**SUBMISSION ON THE NSW GOVERNMENT'S  
CROWS NEST TRANSPORT ORIENTED DEVELOPMENT (TOD) REZONING PROPOSAL**

Submission to the Department of Planning, Housing and Infrastructure

Figure B2.1: Building heights comparison between 2036 Plan and Crows Nest TOD at Block 3 (Source: Urban Design Report marked up by NSC)

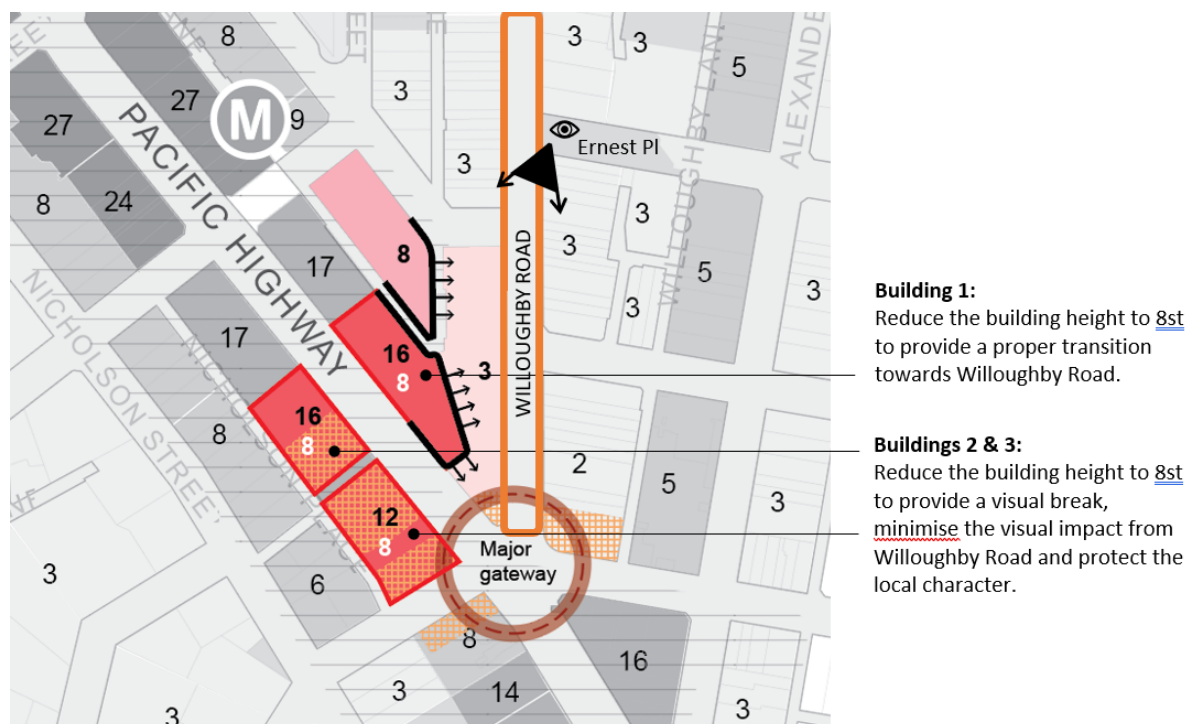
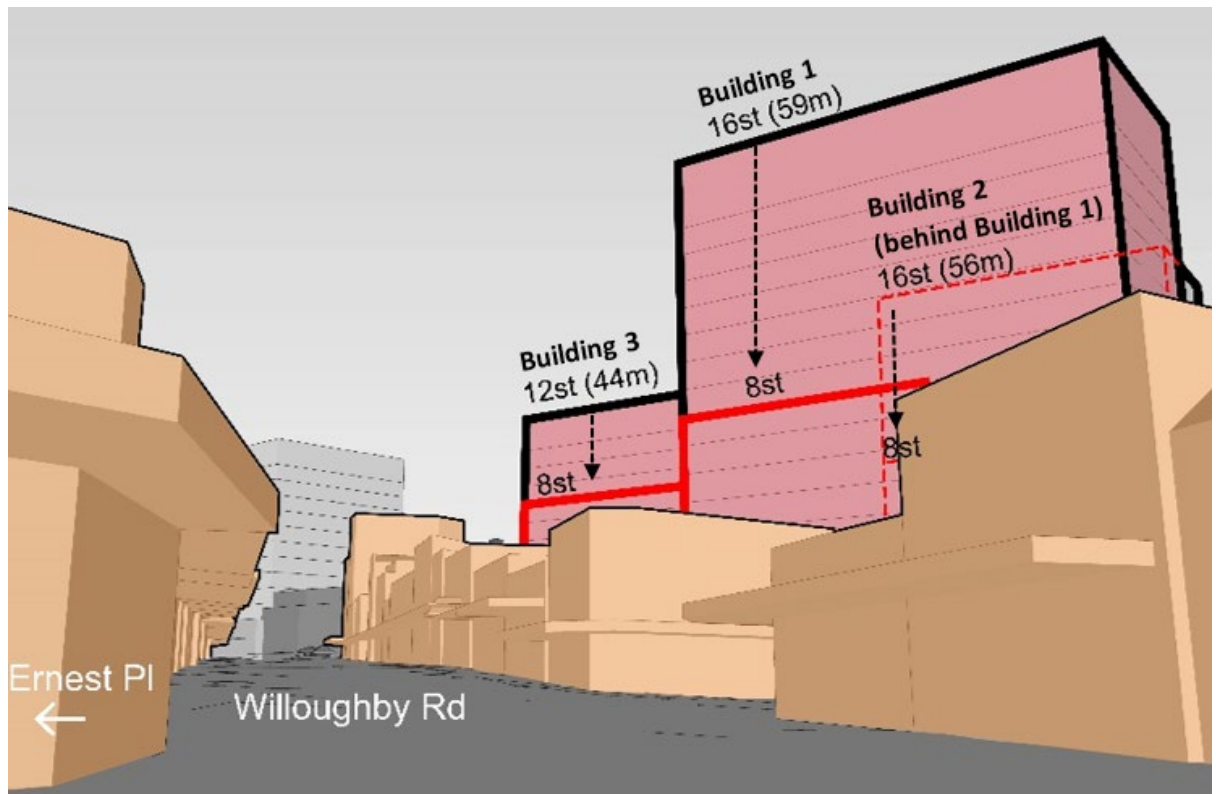
Building 1, which is located adjacent to properties fronting Willoughby Road is proposed to have its building height increased from 8 storeys (as per the 2036 Plan) to 16 storeys (refer to Figure B2.1 and B2.2).

This increase would significantly alter the scale of this sensitive transition area, impacting on the character and amenity of the Willoughby Road streetscape. Figure B2.3 illustrates the view southwards along Willoughby Road, where the proposed 16-storey building would be seen directly behind the fine-grain 2-storey retail shops, creating a bulky visual impact that detracts from the existing character of Willoughby Road. In comparison, the previously proposed 8-storey building height in the 2036 Plan offers a more appropriate height transition, providing a more respectful interface and preserving the high-quality amenity of Willoughby Road.

Buildings 2 and 3, located on the south-western side of Pacific Highway, are proposed to increase in height from 8 storeys (as per the 2036 Plan) to 16 and 12 storeys (refer to Figures B2.1 and B2.2).

- Work with Council to carefully shape and locate towers to improve afternoon sunlight to Willoughby Road and Ernest Place before finalising building heights and FSR
- Reduce the maximum height limit on 437-475 Pacific Highway - Building 1 to 8-storeys
- Work with Council to carefully design the 5-Ways 'Block 3' (including Buildings 2 and 3) which are likely to better support a maximum 8-storey buildings as per the 2036 Plan
- Include a 4m above podium setback along Pacific Highway for 312-348 Pacific Highway in the Design Guide as advised in the Crows Nest TOD Urban Design Report

Figure B3.3 – Proposed building heights diagram (height in storeys)      Figure B2.4 – Proposed LEP HOB map (height in metres)

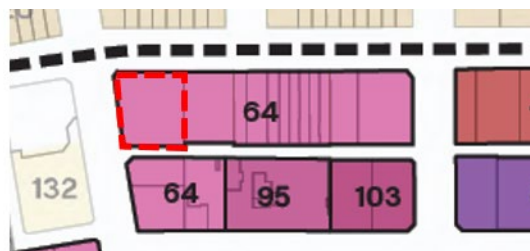
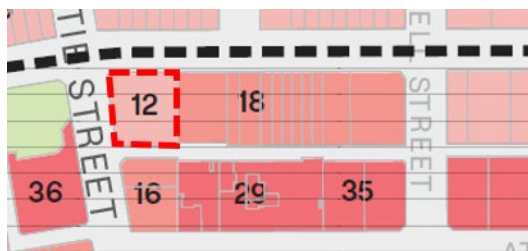
The EIE seeks to increase the maximum building height at 1 Chandos Street to 64m (the equivalent of 18 storeys), consistent with the remaining sites along the southern side of Chandos Street between Christie Street and Mitchell Street. However, the height limit is inconsistent with the anticipated number of storeys for the site, which is identified under the EIE Package and former 2036 Plan as 12 storeys.

Other sites that are envisaged to accommodate 12 storeys have been afforded a maximum height of 43m. Accordingly, a maximum 43m height limit should be applied to this site.

Furthermore, increasing the height limit to that proposed on this site would have detrimental impacts on solar access to Christie Street Reserve, which is inconsistent with the desired solar access outcomes of the EIE Package.

- Apply a maximum FSR of:
  - 2:1 to 7-17 Sinclair Street, consistent with adjoining properties.
  - 8.3:1 to 1 Chandos Street consistent with built for outcomes for this site.
  - 6.5:1 to 11 Chandos Street consistent with the 2036 Plan and adjoining properties.

Figure B7.1 – Propose setback controls map – misalignments and unsupported changes

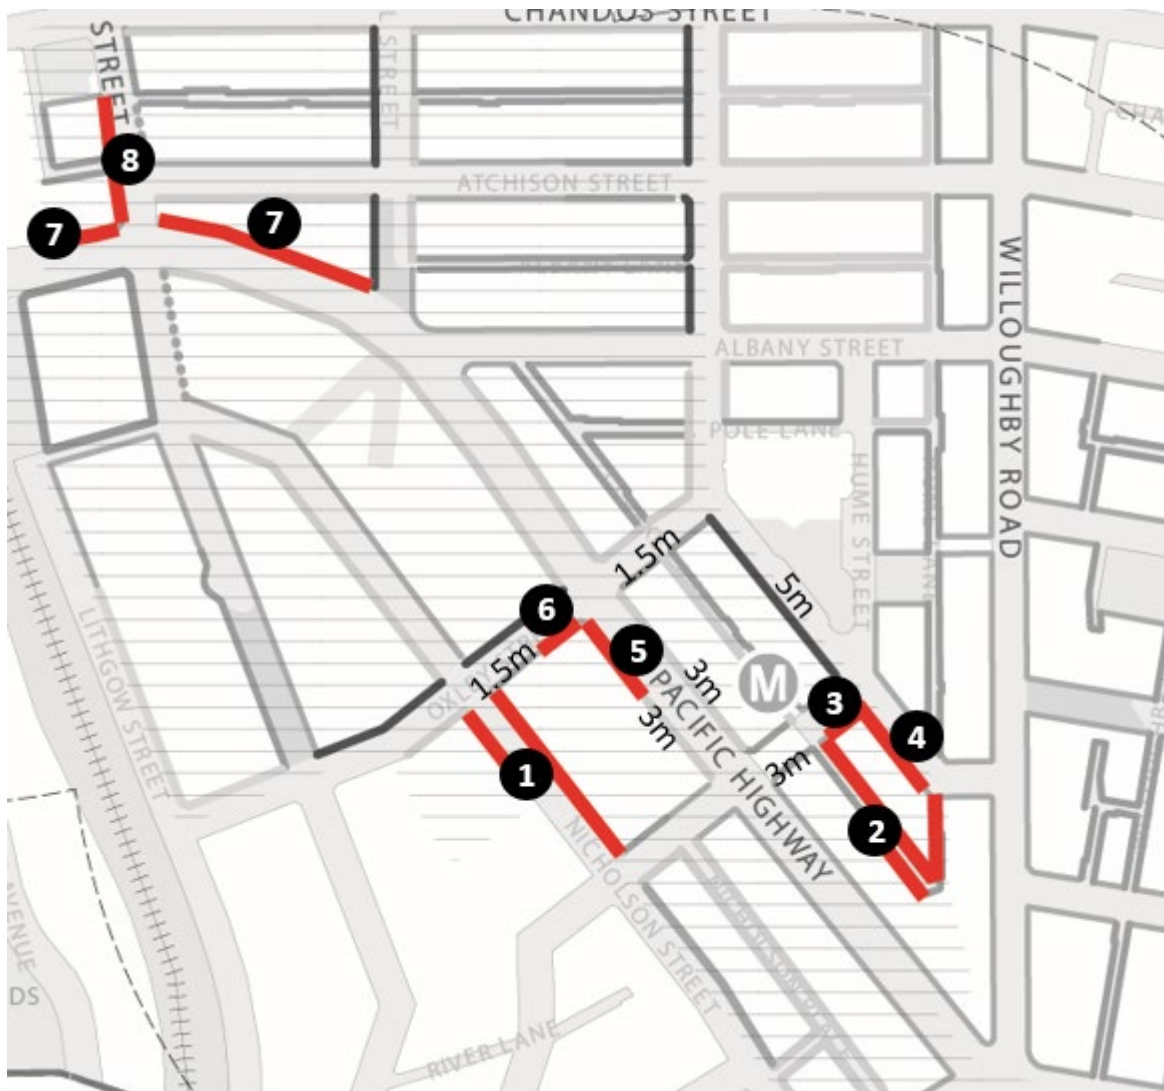
Additionally, the proposed setback controls seek to introduce several modifications in comparison to the 2036 Plan and North Sydney Development Control Plan (NSDCP 2013). Upon review, it is evident that some of the proposed setbacks are not supported as they undermine the desired character of the area and negatively impact on local amenity.

2. Clarke Lane and Hume Lane: A nil setback is proposed to both sides of the laneways. The 2036 Plan sought a 1.5m reverse podium setback along its north-eastern side, while remained silent with regards to its south-western side. NSDCP 2013 specifies a 1.5m whole of building setback to the north-eastern side of the laneways and a varied setback to the south-western side adjacent to the Crows Nest Metro site to align with the SSD Concept Approval. Implementing a 1.5m setback, especially along their north-eastern side would align with the setback further north along Hume Lane, creating a consistent street frontage. Considering the significant foot traffic generated from the Metro Station and the potential through-site link at Hume Lane, a 1.5m setback is essential for pedestrian amenity.

4. Clarke Street: A nil setback is proposed between Hume Street and Hume Lane, and 5m between Hume Street and Oxley Street. Whilst the 2036 Plan was silent, NSDCP 2013 requires a 3m setback (except for Crows Nest Metro Site C which has a 1.2m setback) to allow space for outdoor dining and landscaping. While the 5m setback is welcomed between Hume and Oxley Streets, a 3m setback should apply as it will still enable the ability to provide landscaping and pedestrian activity. In addition, implementation of a 5m setback could adversely impact on the redevelopment potential of these sites, as the depth of the lots would be reduced to approximately 22m.

5. Pacific Highway: A 3m setback is proposed on both sides of Pacific Highway between Oxley Street and Hume Street, except for the northern end of the western side, where a 0m setback is proposed. Both the 2036 Plan and NSDCP 2013 recommend a 3m setback along the entire Pacific Highway frontage for this block to provide a consistent street frontage and sufficient footpath space for pedestrians near the Metro Station. Therefore, to maximise pedestrian amenity, it is recommended that continuous 3m setback be applied.

7. Pacific Highway: A 3m setback is proposed along Pacific Highway, west of Mitchell Street. The 2036 Plan and NSDCP 2013 suggests a 3m reverse setback for the lower two ground levels in this section to allow for footpath widening and to accommodate reasonable development floorplates given the limited width of the sites. It is recommended that a reverse 3m setback be reinstated for these sites.
8. Christie Street: A nil setback is proposed along the western side of Christie Street. Whilst the 2036 Plan was silent with regard to any setbacks along this side of the street. NSDCP 2013 requires a 3m reverse setback along the western side of Christie Street to provide additional space for footpath widening near the railway station and to maintain a consistent street frontage.

- Amend the proposed setback control diagram to correct any misalignment with the section diagram and incorporate Council's recommendations.

Figure B8.1 – Proposed street wall heights map – misalignments and unsupported changes

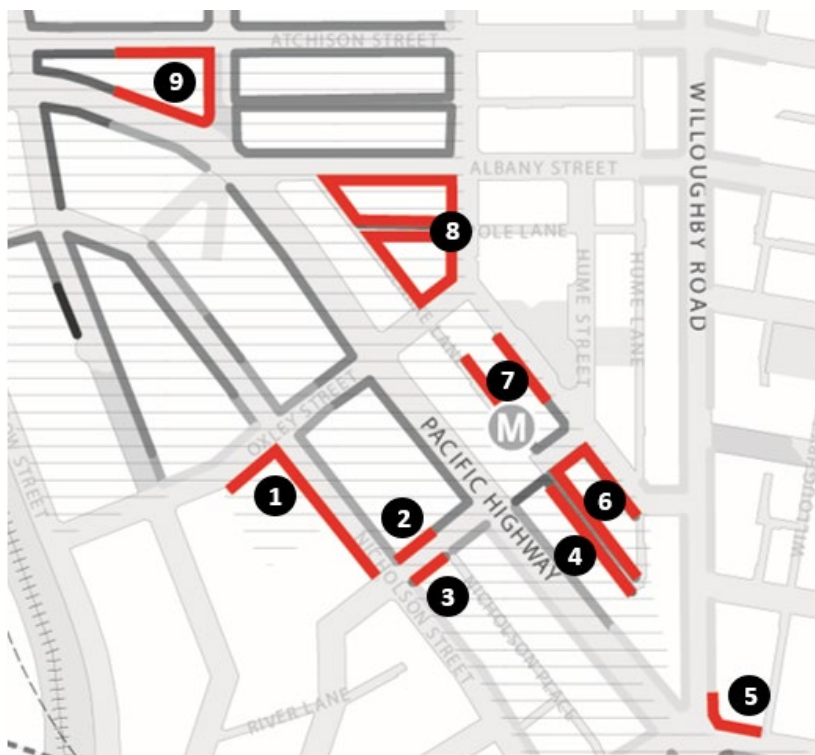
Several discrepancies are noted between the proposed podium height controls in the 3D views, sections, and control map. It is crucial that the Design Guide accurately reflects these controls.

Additionally, some proposed podium heights differ from those under the 2036 Plan and the NSDCP 2013, and are not supported. Details are provided in the accompanying list and diagram (see Figure B8.1) below.

6. Clarke Street, Hume Street and Clarke Lane: The proposed 4-storey street wall with an 8-storey building height contrasts with the 2036 Plan's recommendation of 2 storeys. Due to the site's topography, NSDCP2013 suggests 3 storeys along Clarke Street and Hume Street, and 2 storeys along Clarke Lane. Aligning with NSDCP2013 is recommended for a smoother transition to Willoughby Road.

8. Oxley Street, Albany Street, Clarke Lane and Pole Lane: The proposed 6-storey street wall exceeds the 3-4 storeys of existing buildings as per NSDCP2013. Most sites here are recently built and already comply with the 2036 Plan. The podium heights should be adjusted to match NSDCP2013.

- Amend the proposed street wall height control diagram to correct misalignments with the 3D views and section diagrams and incorporate Council's recommendations.

Figure B10.1 – Hume Street Park

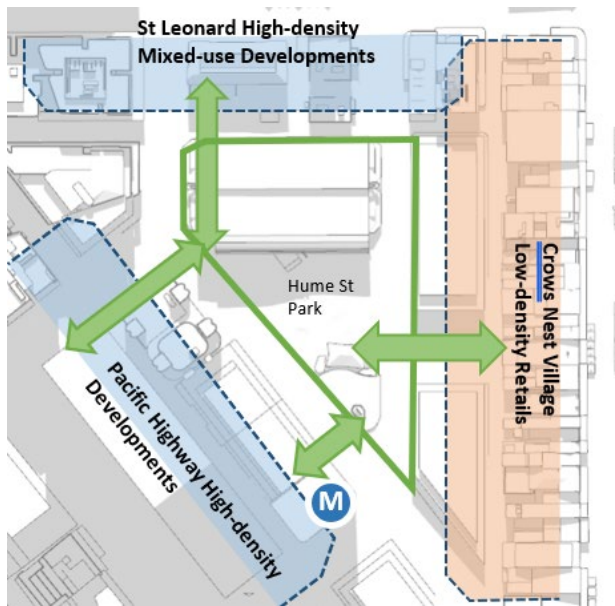
It is evident that the proposed uplift to the Lot 4B development site in the Willoughby LGA, will have a significant impact on Wadangari Park, located on the southern side of Pacific Highway atop the railway line. The resulting increase in density on this site will cause additional shadowing, especially between 2pm and 3pm in mid-winter (see Figure B10.2), resulting in this Park only achieving 50% solar access between 12pm and 1pm. Before 11am and after 2.30pm, the park will be fully shaded.

This situation reinforces the need to deliver a high-quality, recreational space with high levels of solar access. Hume Street Park is well located within the heart of Crows Nest to serve both the local community and visitors. It is also capable of receiving high levels of solar access, due to the need to protect the low-rise character of Willoughby Road to the east. Accordingly, public domain opportunities and related funding mechanisms for upgrade, expansion and embellishment of Hume Street Park need to be considered and included in the Design Guide.

- Add clear objectives and provisions in the Design Guide to identify the public domain opportunities and related funding mechanisms to rejuvenate Hume Street Park.

Figure B22.1 - Land use map from Design Guide

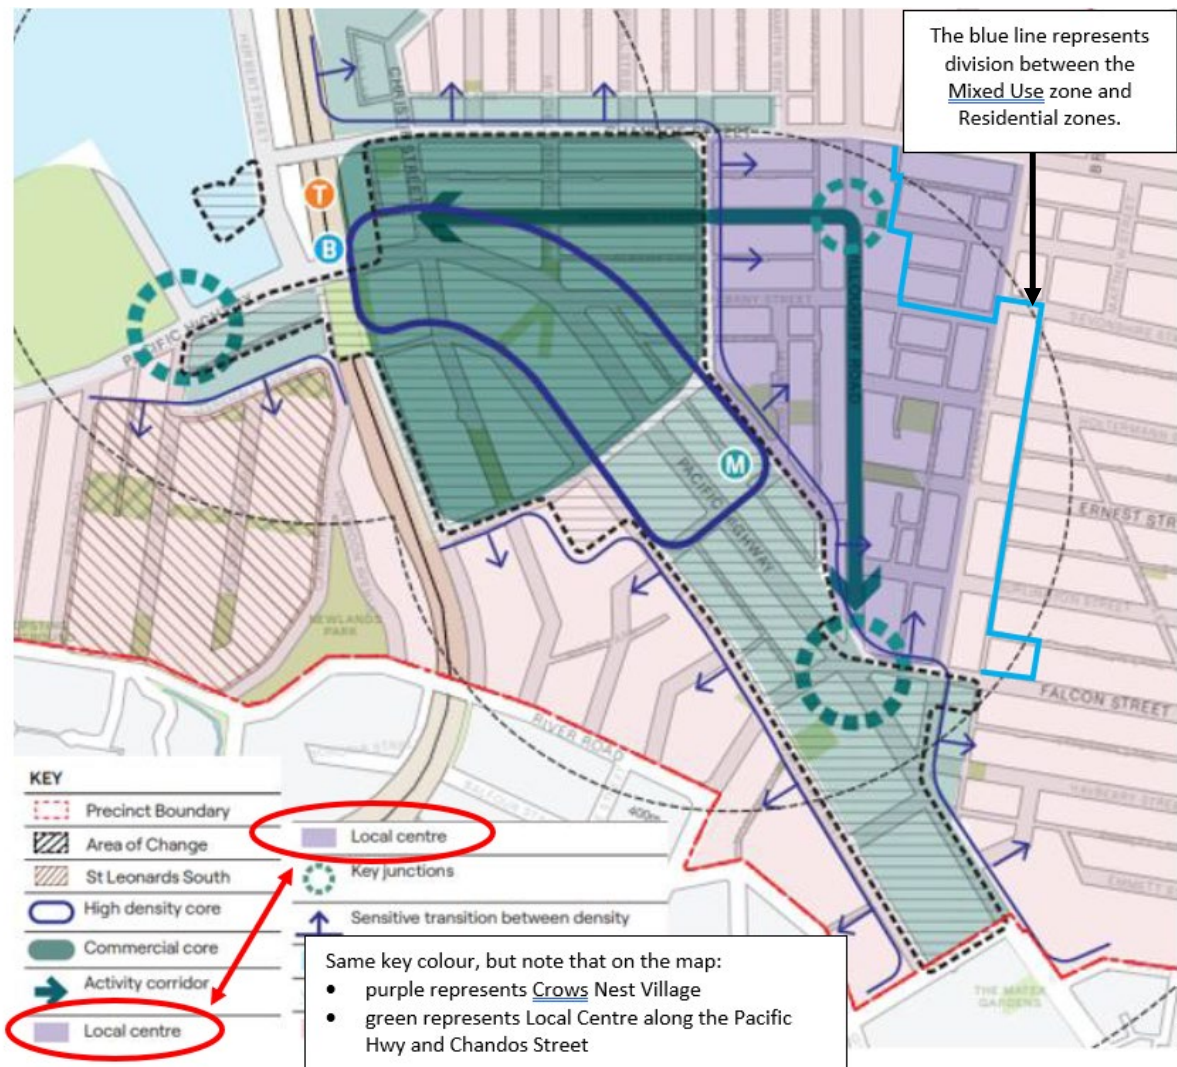
The land use map contains a number of errors in relation to the extent of the Crow Nest Village (local centre) and the key.

The Map incorrectly labels the mixed-use zones along the east side of Alexander Street between Falcon Street and Devonshire Street as residential areas. In addition, a residential area generally located between zigzag Lane, Chandos Street, Aleander Street and Albany Street is shown as part of the local centre (refer to Figure B22.1)

This error needs to be corrected to accurately reflect the intended land use.

Figure B24.1 – Built form design recommendations – Urban Design Report

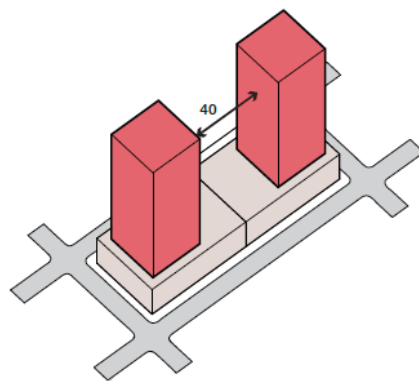
The Urban Design Report suggests a 40m separation between towers along Pacific Highway (see Figure B24.1) to enhance sensitivity to the local character and context.

To preserve amenity for Wollstonecraft residents and pedestrians, it is recommended that a new provision be provided within the Design Guide requiring:

Figure B28.1: Extract of Figure 8 to the Design Guide and extent of missing public open spaces where solar access is to be protected.

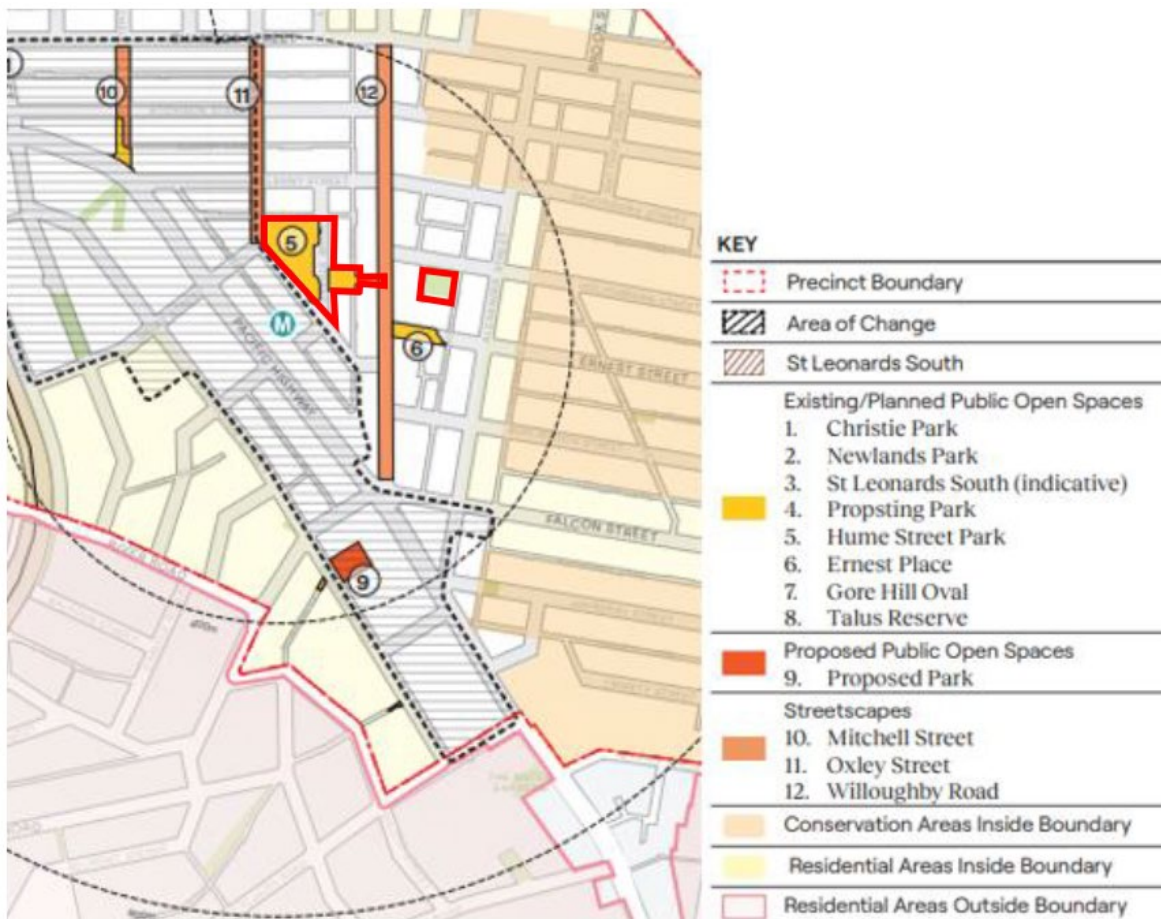
The proposed solar access map fails to correctly identify the full extent of Hume Street Park, which includes the road reserve of Hume Street. This road reserve is zoned as RE1 in the North Sydney Local Environmental Plan (NSLEP2013) and is expected to be transformed into part of Hume Street Park in the long term. The solar access map should be updated to reflect this consolidated space accurately.

Additionally, no solar access protection is being proposed for any future Holterman Street Park, as identified in the 2036 Plan. The NSDCP2013 includes a solar access protection control for this future open space. It is recommended to add Holterman Street Park to the solar access protection areas.

Figure B32.1 – Block 4 section – Urban Design Report

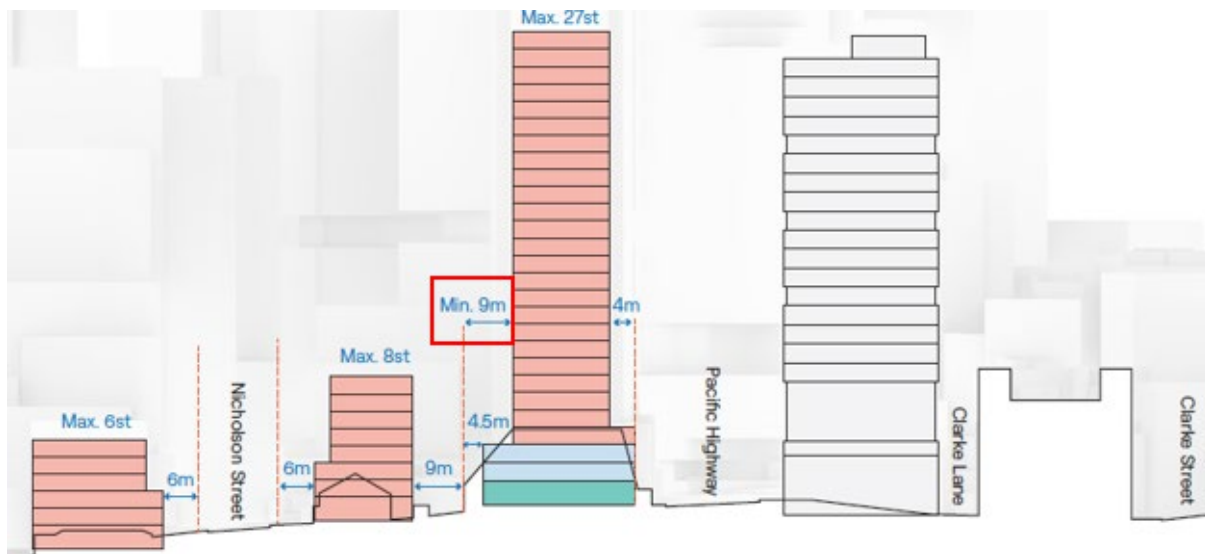
The cross sections from the Urban Design Report for opportunity blocks detail minimum tower setbacks along Nicholson Street and Sinclair Street (see Figure B32.1), which are reflected in the 3D models and align with the proposed FSR. However, these setback controls are not reflected in the Design Guide. To ensure the intended design outcomes are met, it is essential to include these minimum tower setback controls within the Design Guide.
